Work Order ID 89888

Item Name: Crosstube Turning Detail

DART AEROSPACE LTD	Work Order: 89888
Description: Crosstube Assembly	Part Number: D407-667-145
Inspection Dwg: D407-667-145 Rev: C	Page 1 of 2

DRAWING NO. D407-667-145	TITLE CROSSTUBE ASS'Y (407 HIGH FWD)	REV. C	DART AEROSPACE LTD ENGINEERING ORDER		D.E.O. NO. D407-667-145-C-1	SHEET NO. SHEET 1 OF 1	SCALE NTS
DRAWN <i>q</i>	CHECKED <i>ASS</i>	MFG. APPR. <i>IB</i>	APPROVED <i>WD</i>		DE APPR. <i>HA</i>		
DATE 11.07.15	DATE 11.07.22	DATE 11.07.22	DATE 11/07/22		DATE 11.07.21

C TURNING DETAIL

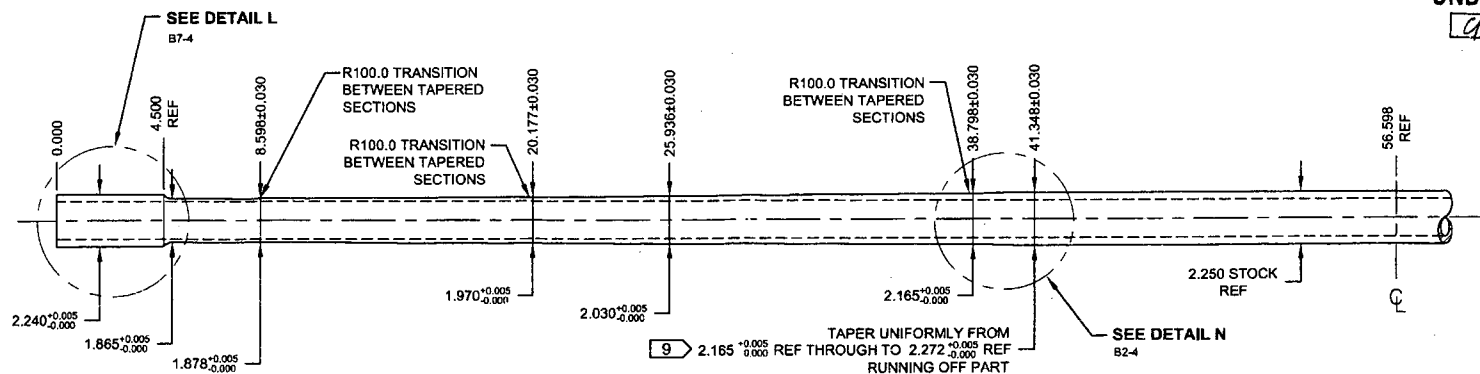
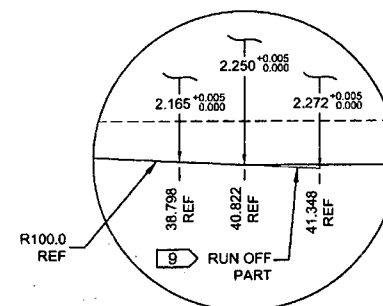
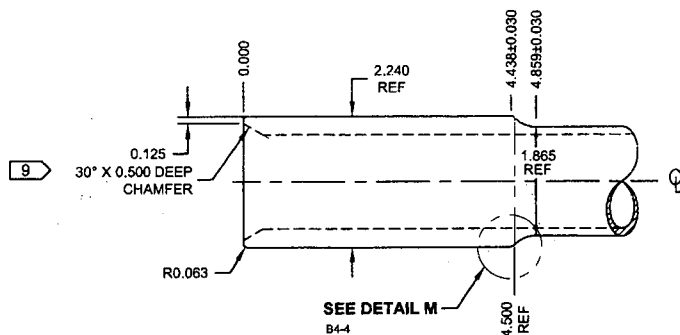
Root Cause	Date	Step	Qty	Description of work order update or Non-conformance	Initial Chief Eng	Action Description	Sign & Date	Verification	QC Inspector		
Doc/Data <input type="checkbox"/>	12/10/2	100	1	Cuffs are over tolerance 2.247" - 2.247" 2.246" - 2.249"	DAS 12/03 12/10/2	Acceptable	DAS 12/03 12/10/2	JW 12-10-3	DAS 16/03 12/10/18		
Equip/Tooling <input type="checkbox"/>											
Operator <input type="checkbox"/>											
Material <input checked="" type="checkbox"/>											
Setup <input type="checkbox"/>											
Other <input type="checkbox"/>											
Process <input type="checkbox"/>											
Supplier <input type="checkbox"/>											
Training <input type="checkbox"/>											
Unapproved <input type="checkbox"/>

DETAIL P
BONDING STRAP INSTALLATION 2 PL

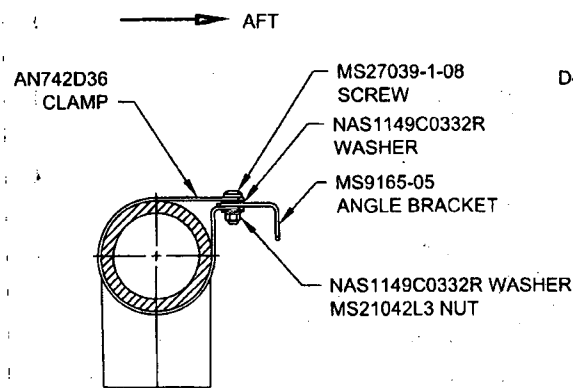
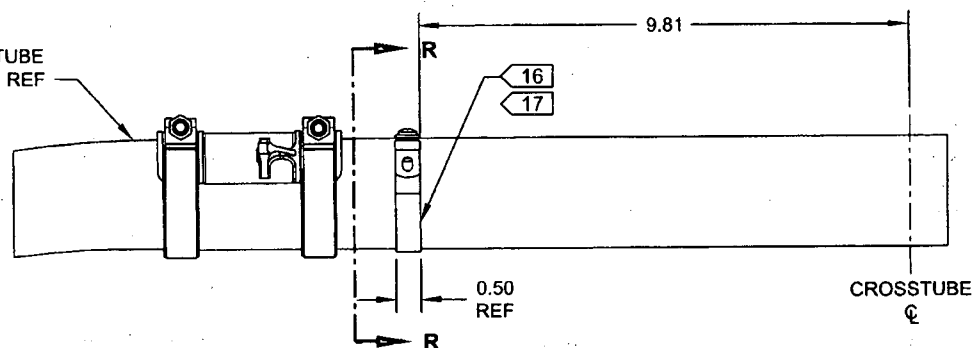
PURPOSE:

ADD ELECTRICAL GROUNDING STRAP

ITEM	QTY -145	PART NUMBER	DESCRIPTION
1	X	D407-667-145	CROSSTUBE ASSEMBLY (407 HIGH FWD)
10	2	AN742D36	CLAMP
11	2	MS9165-05	ANGLE BRACKET
12	2	MS21042L3	NUT (OR MS21042-3)
13	2	MS27039-1-08	SCREW
14	4	NAS1149C0332R	WASHER (OR AN960C10L)

- 16) MASK AREA UNDER CLAMP PRIOR TO PAINTING
- 17) SEAL EDGES WHERE AN742D36 CLAMP MEETS WITH THE CROSSTUBE USING SIKAFLEX-241/-291 OR MIL-S-8802 CLASS B2 OR PROSEAL 890 SEALANT
- 18) PERFORM RESISTANCE CHECK TO ENSURE MAX RESISTANCE IS 10 MILLIOHMS
